DESIGN REVIEW BOARD DECISION

FILE NUMBER: DRV18-00312

PROJECT NAME: CONTINENTAL DIVIDE MIXED-USE PROJECT
CONTINENTAL DIVIDE LLC

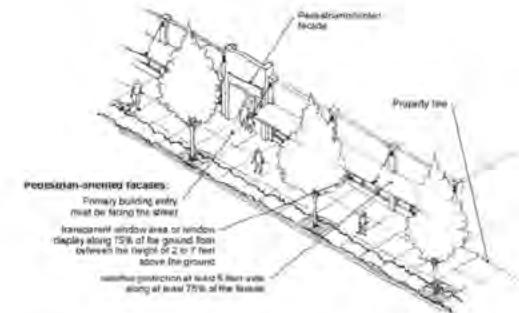
- Submit an updated formal setback modification request. The request should address the criteria in KZC Section 142.37.
 - a. Also include a site plan that highlights all the encroachments.

There were originally 4 Minor Variation Setback Requests (balconies facing 131st and 132nd, the NW driveway, and the buildings facing 85th Street). As shown by the red dashed line on the accompanying site plan, the balconies and driveway all comply with the prescribed setbacks and therefore no Design Departures or Minor Variations for these features are requested.

Criteria 4.a.: The most relevant aspect of design with regard to this request is the placement itself of the buildings on the site plan. The question regarding building placement on the NE 85th Street Frontage is,

"GIVEN THE 3 OPTIONS IN FIGURE 19, PAGE 15 OF THE DESIGN GUIDELINES FOR ROSE HILL EAST END NE 85TH STREET FRONTAGE, WHICH IS A SUPERIOR DESIGN TO THE STATED SETBACK REQUIREMENT?"

Considering that the goal of the policy basis is to create pedestrian friendly storefronts on NE 85th Street, the top option (shown below) is the one that conforms with best planning practices to have the storefronts right at the edge of the sidewalk. That is, at the property line where the pedestrian interface occurs; not setback from the property line. Note that in this Design Guideline recommended option, the building is placed such that the storefronts are at the property line.

ITEM 2 | SITE PLAN - LIGHTING

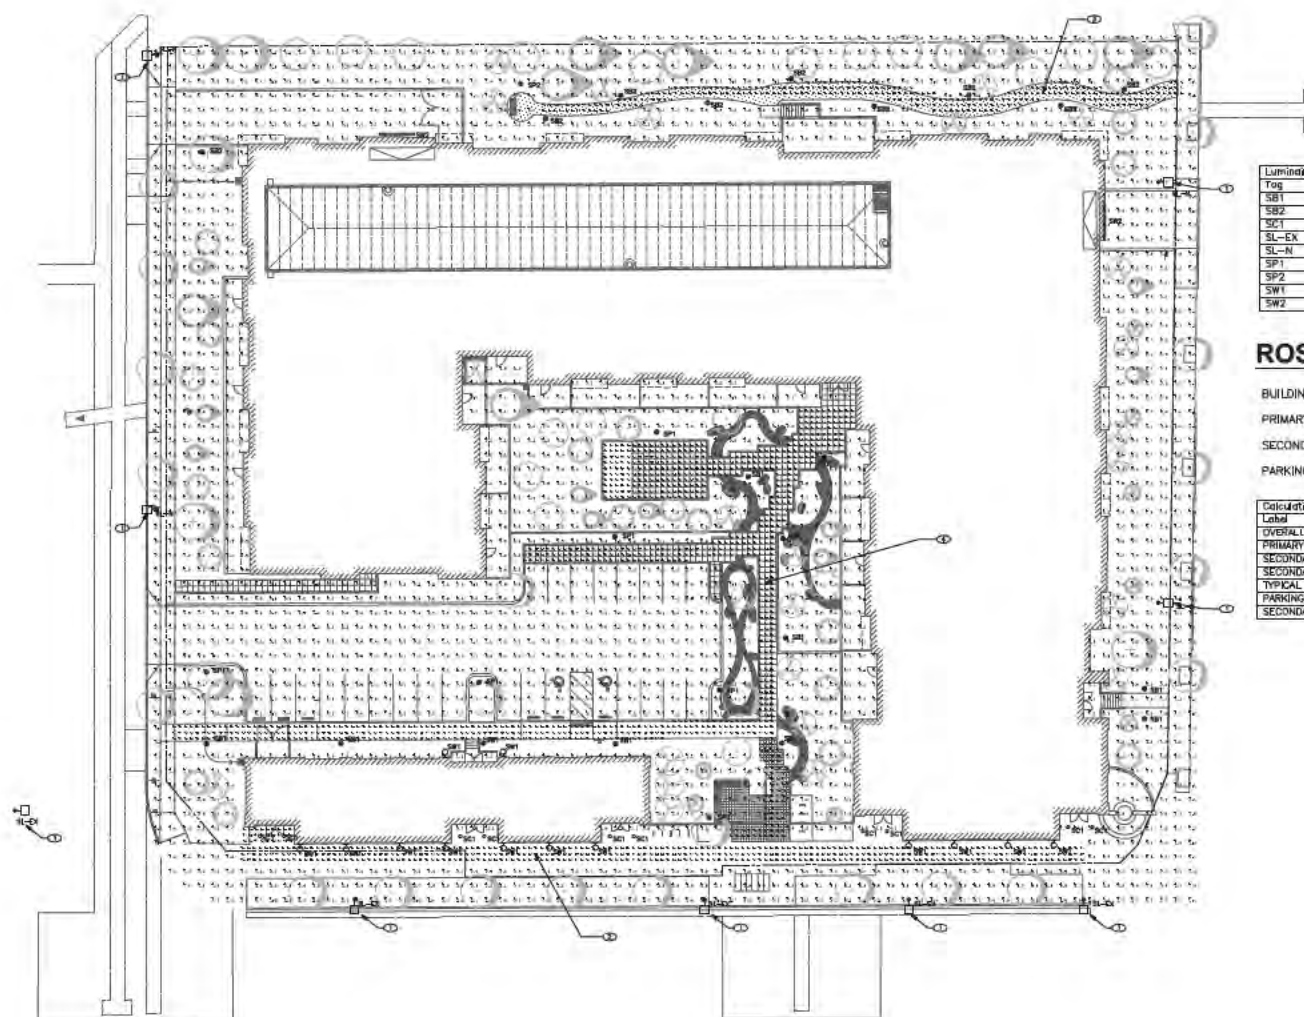
- Submit a lighting plan that addresses the Design Guidelines contained in Section 9 - Lighting.

ITEM 4 | ELEVATIONS

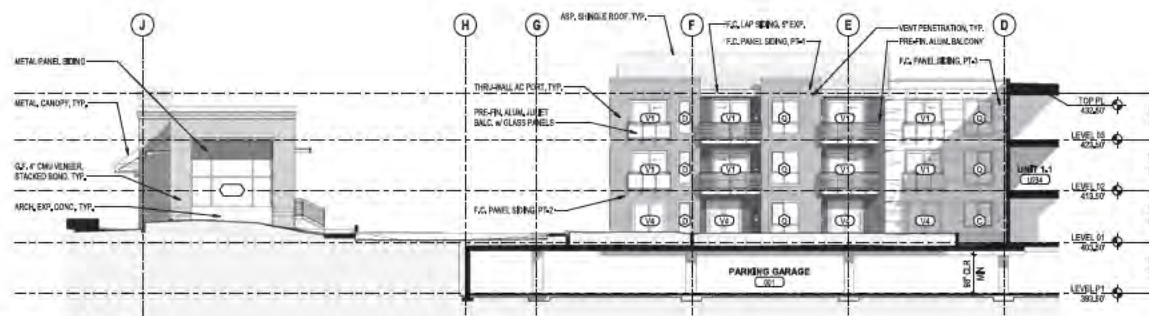
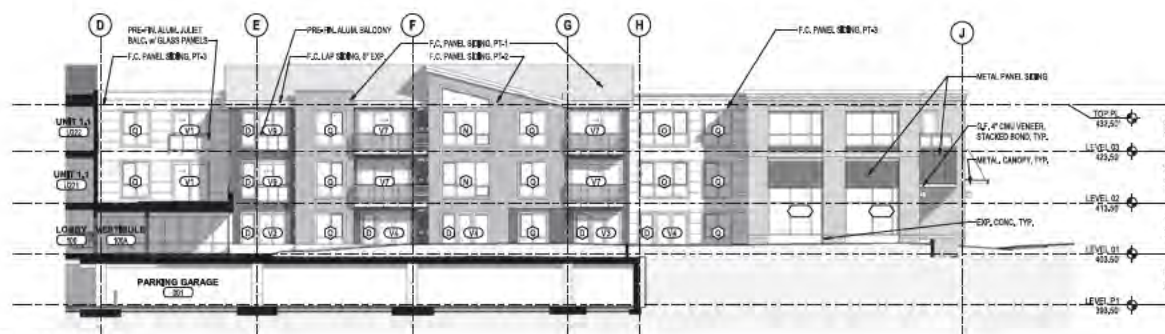
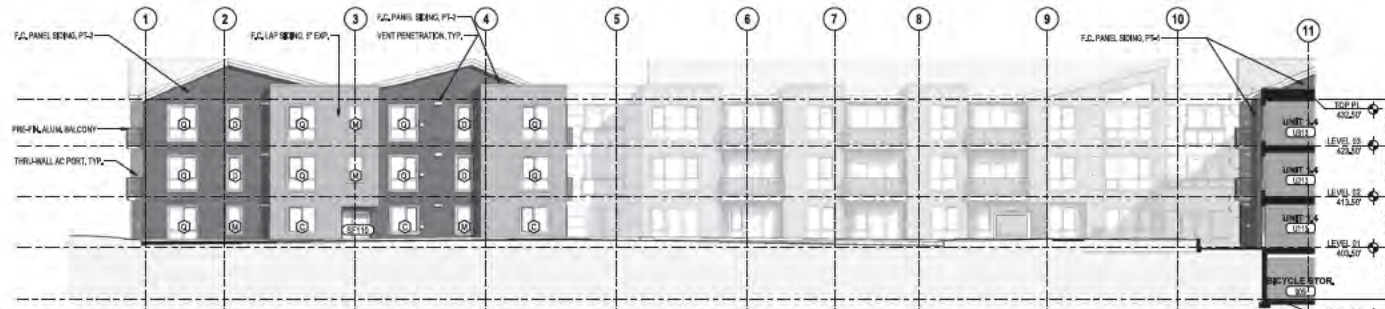
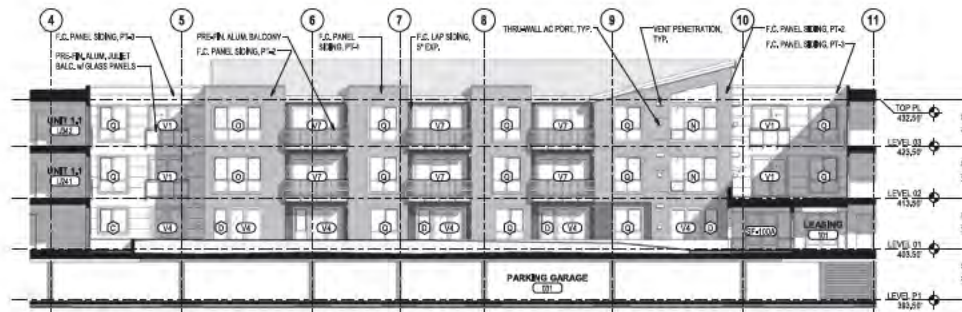
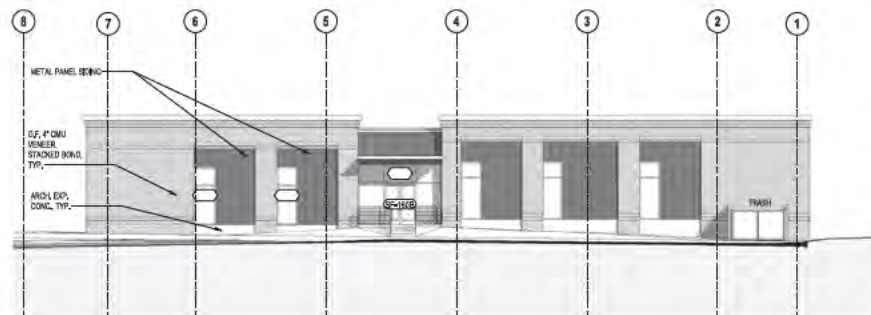
- Provide elevations for all facades for each building including the north facade of the standalone commercial building.

ITEM 8 | BLANK WALLS

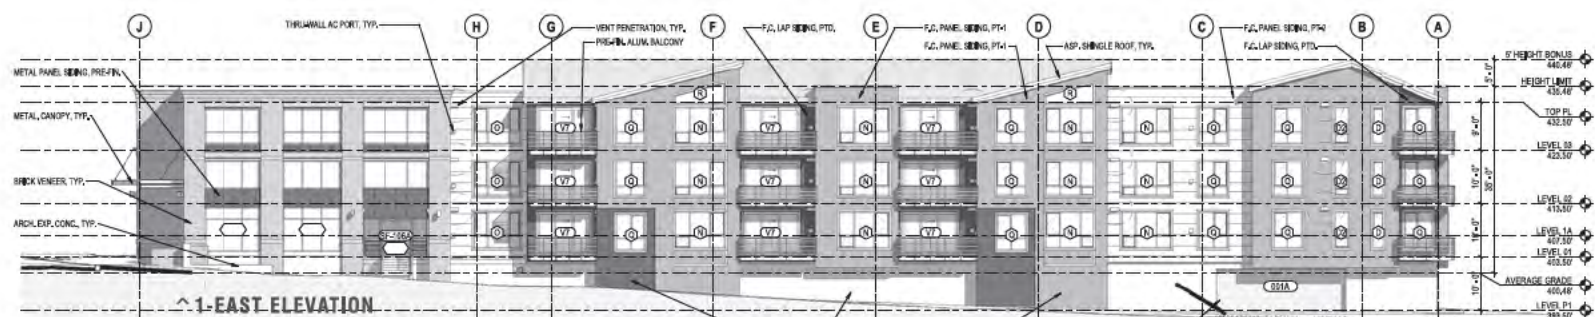
- Additional development of the standalone commercial facade to create a superior design to offset the modification request. Ideas include material changes on the parapets and cornice treatments. We recommend looking at the Hectors Building on Lake Street and the Park Lane Public House for some ideas.
 - a. Also address any blank walls on the backside of the building (See Design Guideline Section 8)
